2 Changes to Proposal

Rezoning and DP Resubmission

1737 Rockland

June 13, 2023

Building A Modifications

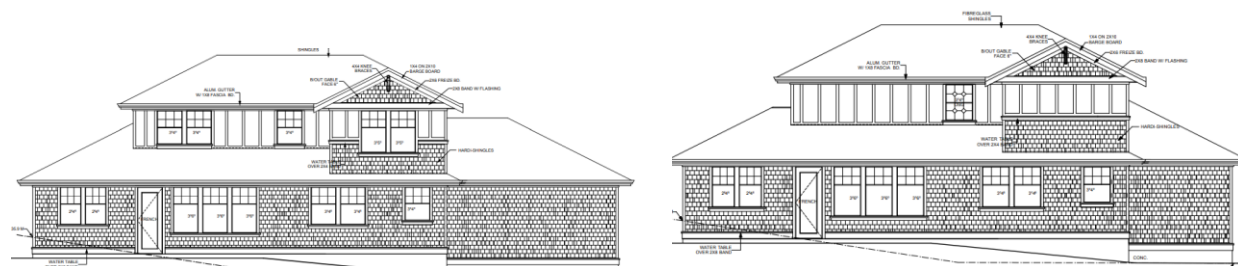
All upper bedroom windows had been removed from the rear (south), to eliminate any possible overlooks to the neighbour on Lyman Duff. The only window on this elevation is an obscured bathroom window.

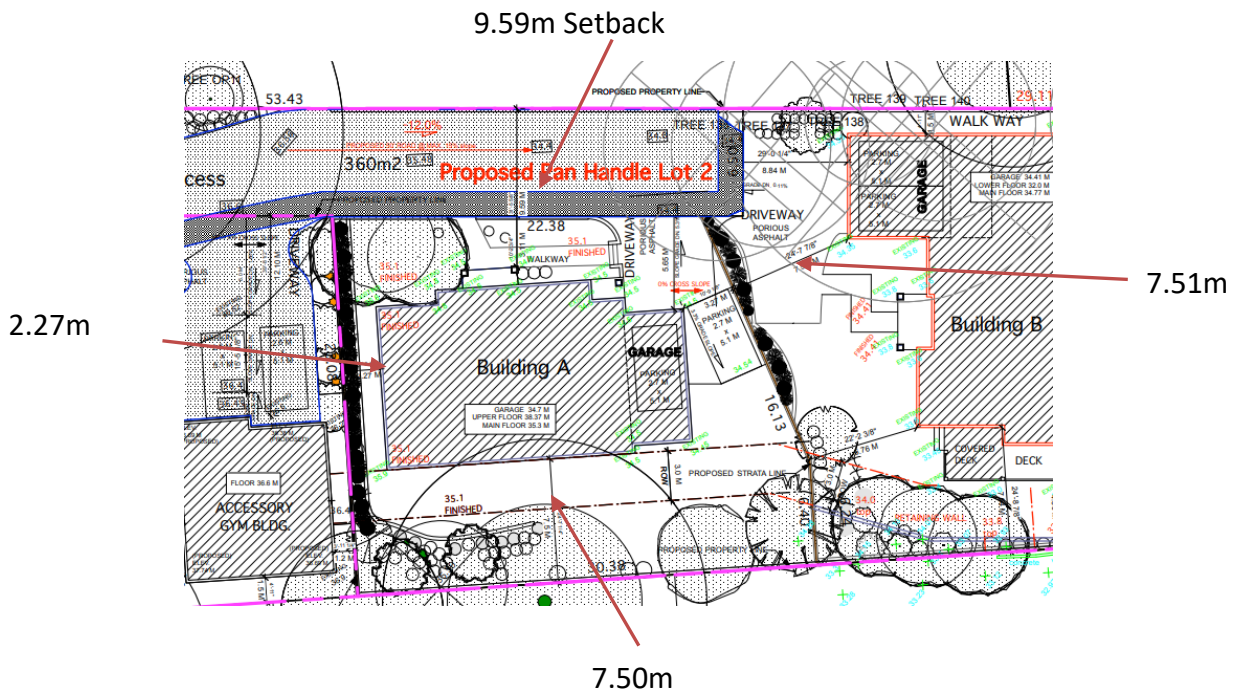
To help reduce visual impact the building height was reduced from 6.87m to 6.6m by changing the top floor ceiling height to 8'.

The panhandle zone calls for a single storey building, again in support of privacy. However, the size of the lot allows a second storey because there are sufficient setbacks (see below) to avoid privacy concerns. Note the second floor is stepped in significantly and is about half the size of the main floor, making this a 1 ½ storey building.

Tree in neighbour's yard

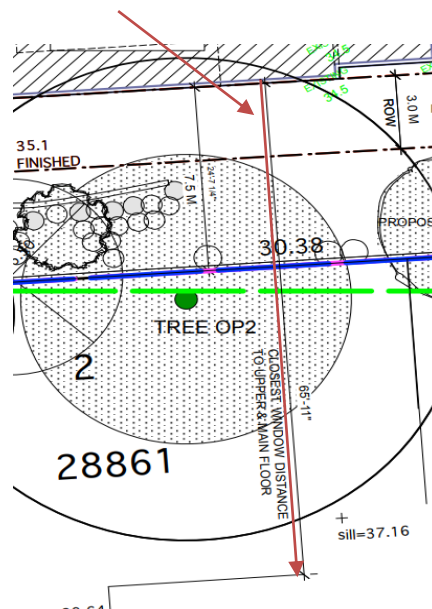
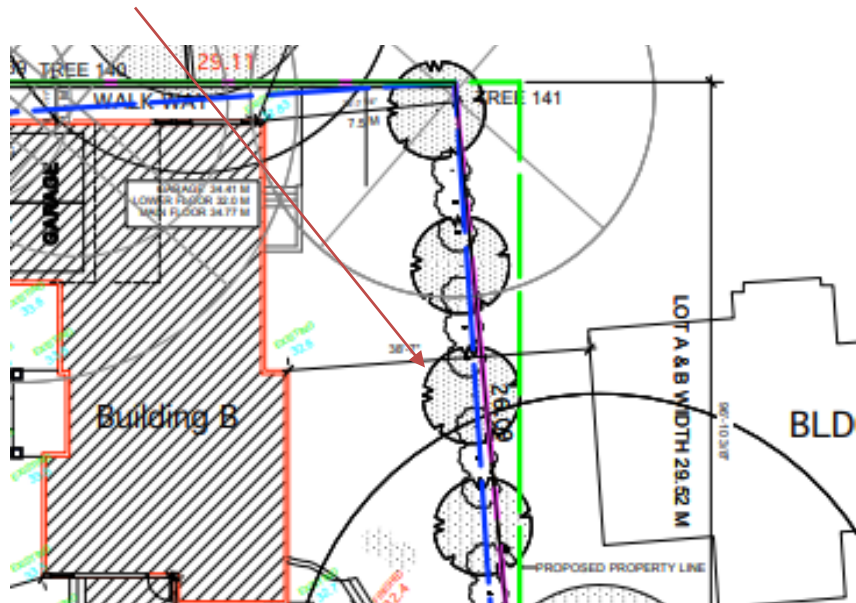
To further illustrate privacy protection, the distance from the proposed house to the neighbours closest window is almost 20m.

There is also a large tree in the neighbour's yard obscuring any visual impact. As well, the neighbour's deck is higher which actually looks over/down onto proposed building A suggesting there will be very little, if any, privacy impact for this neighbour.

East Neighbour

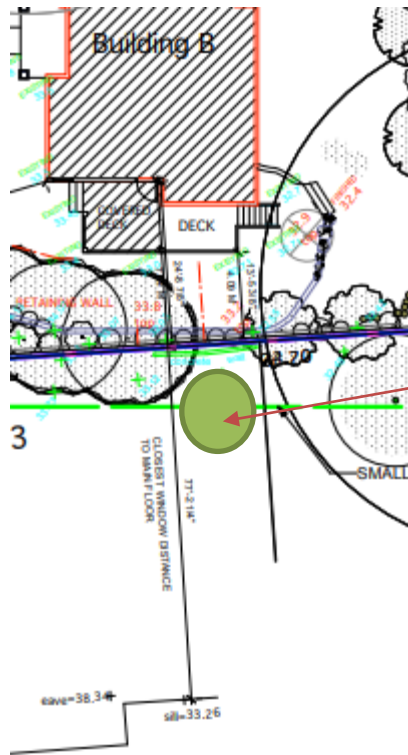
Building B was pulled to the west (moved 'forward') which increased the east (rear) setback from 5.0m to 7.5m, to align with policy. The actual distance between the buildings (to the east neighbour) is 11.8m.

Notably, the east elevation faces the side yard of our neighbour, and more specifically is adjacent a side where there are very few windows. In addition to the increased setback the neighbour's rear yard and recreation area is further obscured by a large tree on their property.

Tree planted for additional privacy on neighbour's property

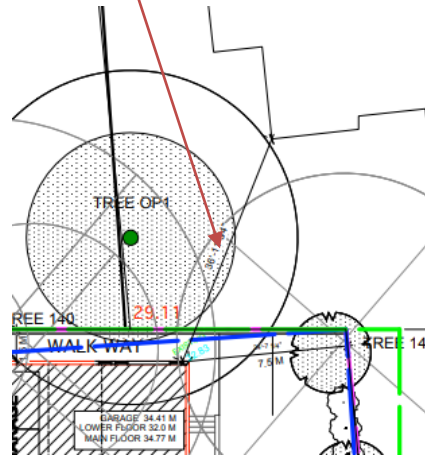
To bring the application closer to policy, Building B design was significantly modified to allow the south setback to now be 7.5m (to a habitable window). The actual distance between the buildings is 23.5m, or 19.4m from the deck.

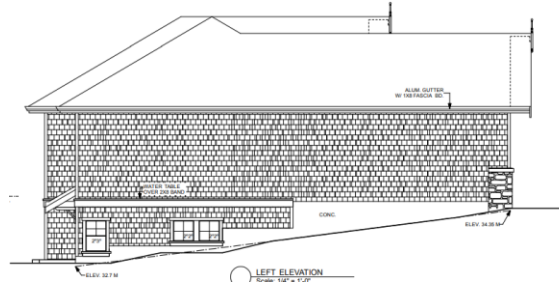
The north set back is 1.5m, which is the typical interior side yard setback. Note the actual distance between buildings being 11.3m.

On the north elevation all upper windows were removed to eliminate overlooks. This side of building B is meant to be a simple pathway to the suite. There are no areas to recreate.
